ARCHITECTURAL REVIEW COMMITTEE MEMORANDUM

SUBJECT: ALEX GONZALES, OWNER, REQUESTING A LAND USE PERMIT AND A WAIVER FOR A SHADE STRUCTURE ON THEIR EXISTING PARKLET LOCATED AT 101 SOUTH PALM CANYON DRIVE, ZONE CBD, (CASE 21-075 LUP). (AP)

FROM: Department of Development Services

TAHQUITZ CANYON DRIVE

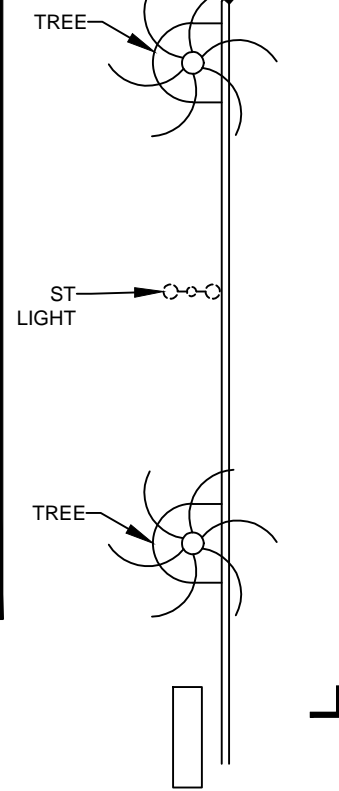
- Modifications to the existing platform deck so that it does not impede the flow of stormwater and drainage.
- Replace the existing shade structure with non-flammable materials.

- Modify the existing platform deck so that it does not impede the flow of stormwater

and drainage.

- Replace the existing shade structure with non-flammable materials.
